**Economic and Social Council**Distr.: General
14 June 2016

Economic Commission for Europe**Inland Transport Committee****World Forum for Harmonization of Vehicle Regulations****Working Party on Noise****Sixty-fourth session**

Regulation No. 28 (Audible warning devices)**Proposal for Supplement 5 to Regulation No. 28****Submitted by the expert from the Russian Federation***

The text reproduced below was prepared by the expert from Russian Federation in accordance with a decision at the sixty-first session of the Working Party on Noise (ECE/TRANS/WP.29/GRB/59, para. 5) to align the provisions of Regulation No. 28 with the current rulemaking practice. The consolidated text below is based on document ECE/TRANS/WP.29/GRB/2016/2, takes into account comments provided in informal documents GRB-63-04 and GRB-63-15 and the outcome of the meeting of interested experts held in Moscow on 10 June 2016. A new approach is introduced to allow further extension of this Regulation to other audible warning devices not yet regulated at UN level. The proposed amendments to the current Regulation are incorporated into the consolidated text and marked in bold for new or strikethrough for deleted chara

I. Arrangement of the approval mark of the audible warning device, audible warning system, multiple audible warning system

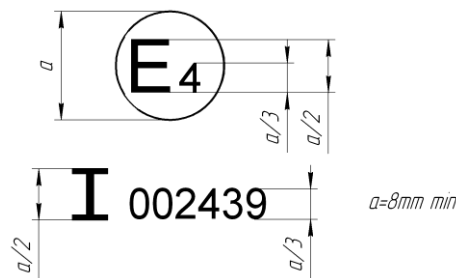
16. Specify the types of approval markings. The text is modified in accordance with the present practice.

Figure 1

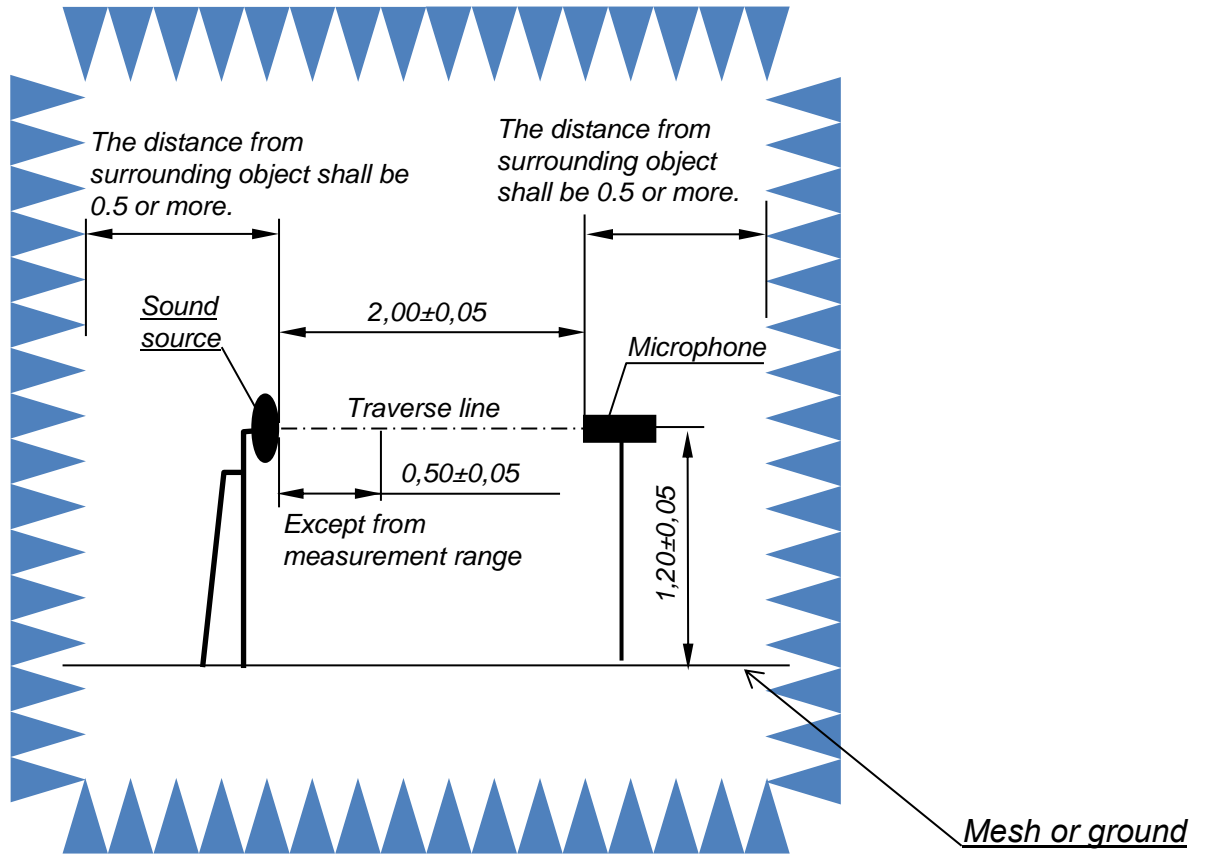
- A minimum of 10 points shall be used for evaluation on the microphone traverse line. The measurement shall start at 0.5 ± 0.05 m from the sound source, and spacing shall be 0.15 m (e.g. Figure 1);

12. The reference to the requirements for anechoic and semi-anechoic chambers in Annex 3 is added.

Microphone positions for measurements of acoustics parameters of audible warning device, audible warning system, multiple audible warning system

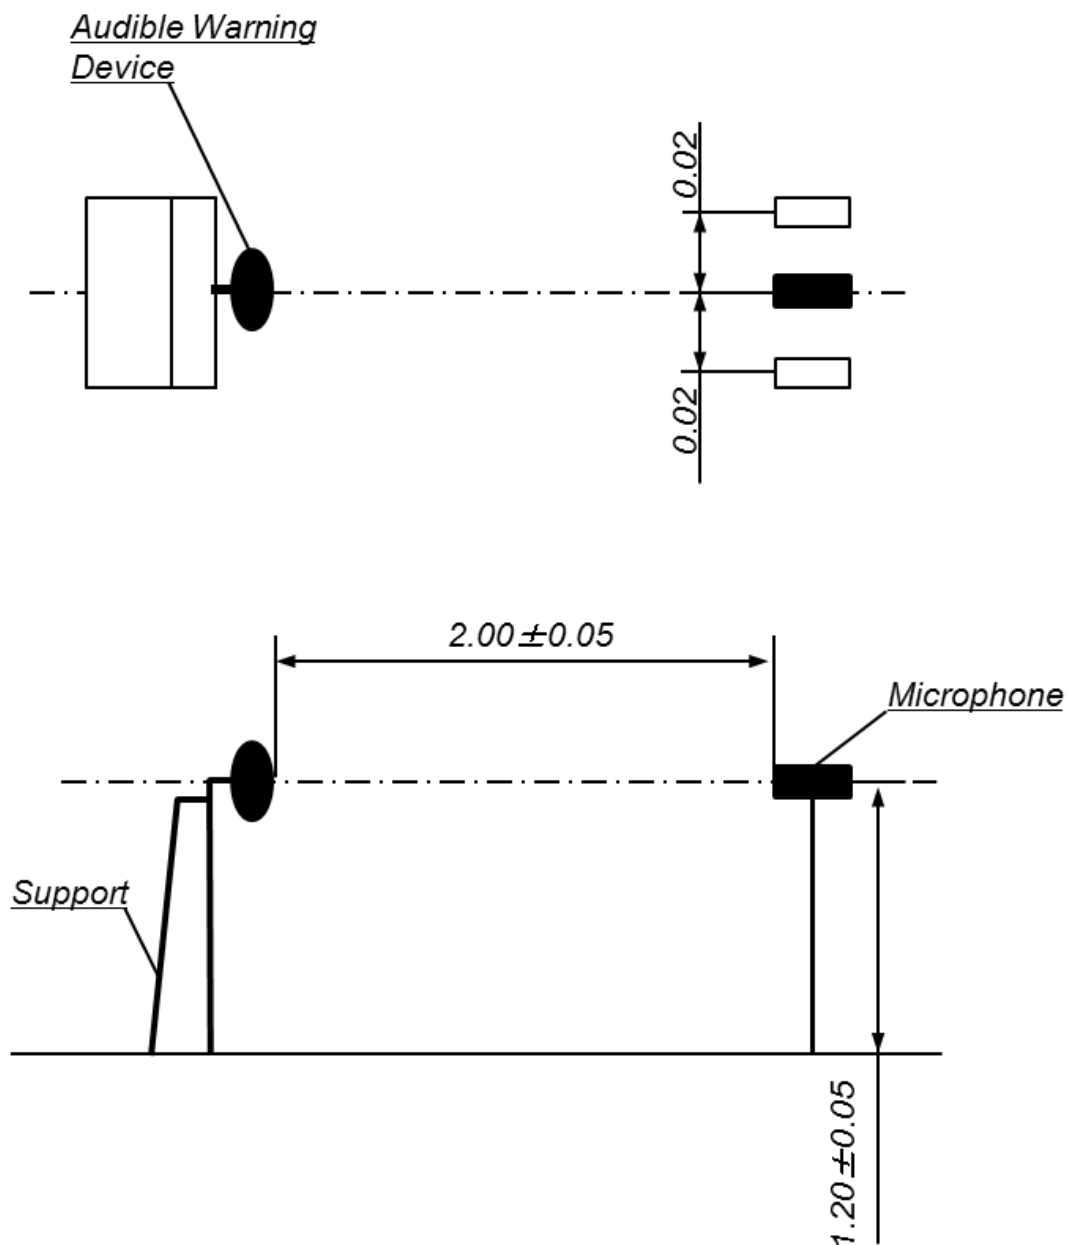
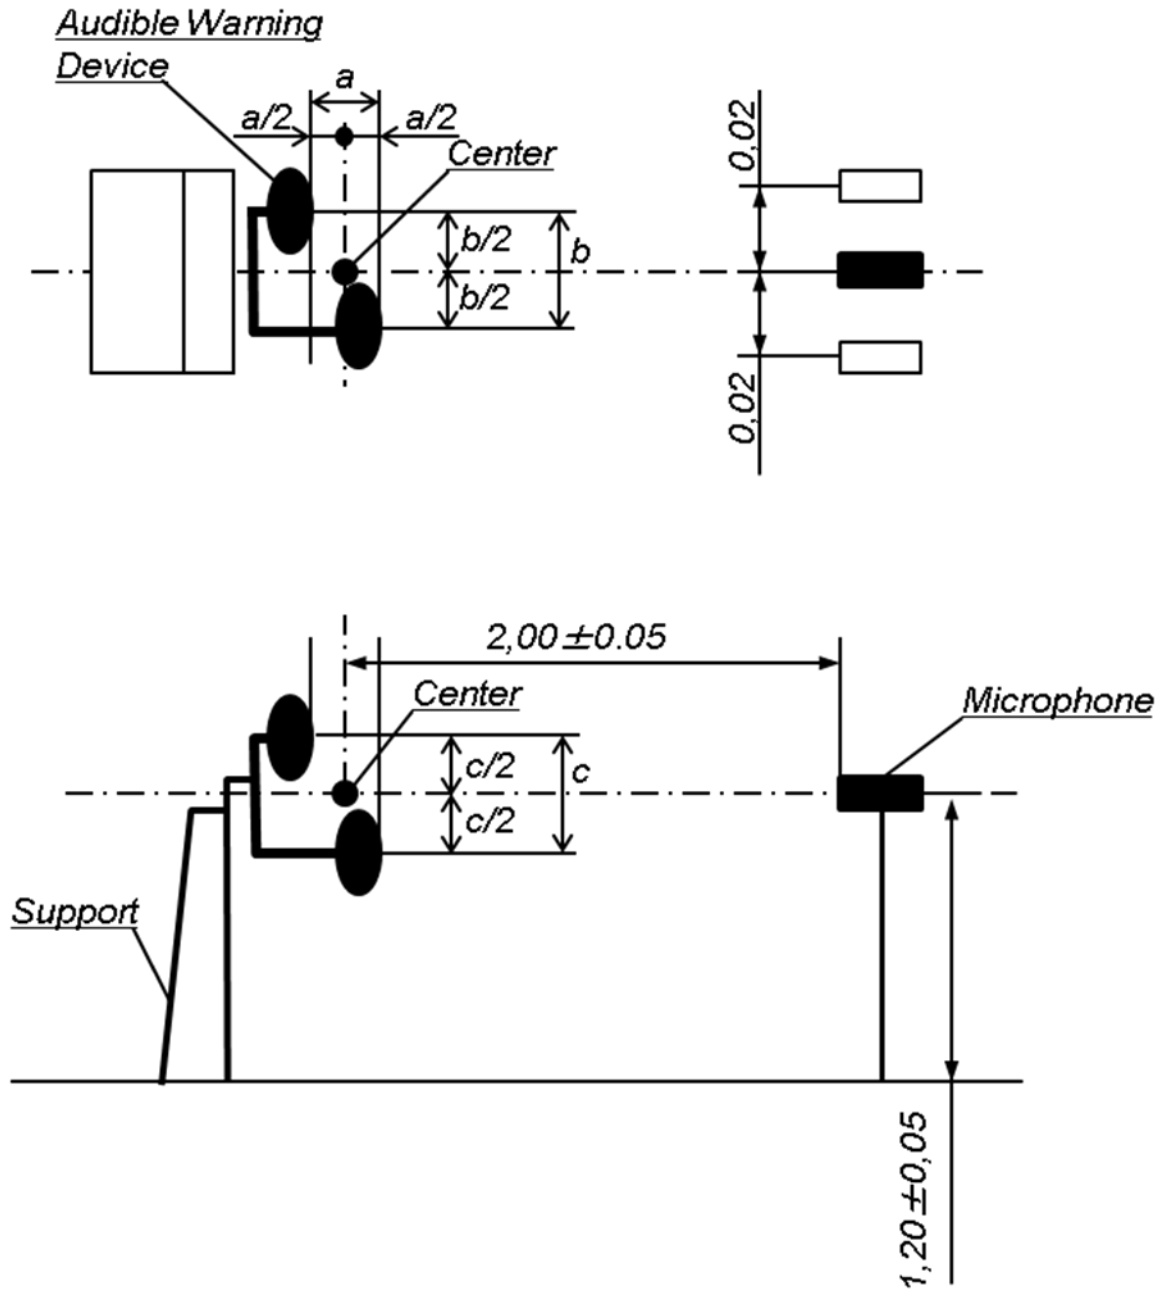
The microphone shall be so placed that its diaphragm is at a distance of 2.00 ± 0.04 **0.05** m from the plane of the sound outlet of the **audible warning device, audible warning system, multiple audible warning system. The microphone must be positioned facing the front surface emitting sound of the audible warning device, audible warning system, multiple audible warning system in the direction in which the maximum sound level can be measured. See figure in Annex 4.**

13. The text provides for clarification on the positioning of the measuring microphone during the tests. The reference to the Annex 4 is added.

Microphone positions for measurements of audible warning signals of motor vehicles

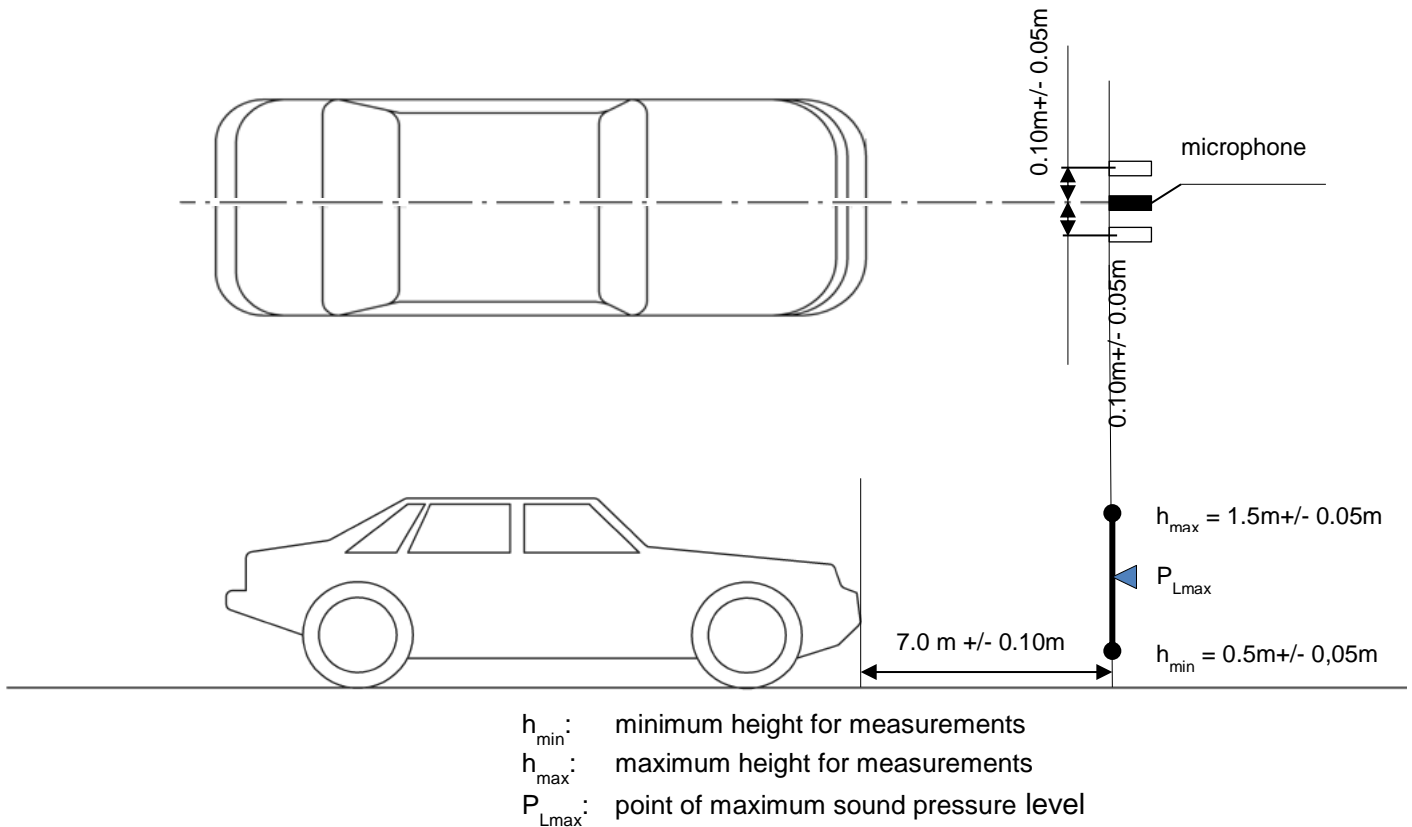
1. Sections 7, 10, 15, 19 reflect the change of headers. A new section 18 is added. A new Annex 3 is added with qualification criteria for anechoic space. New Annexes 4 and 5 are added with graphical information.
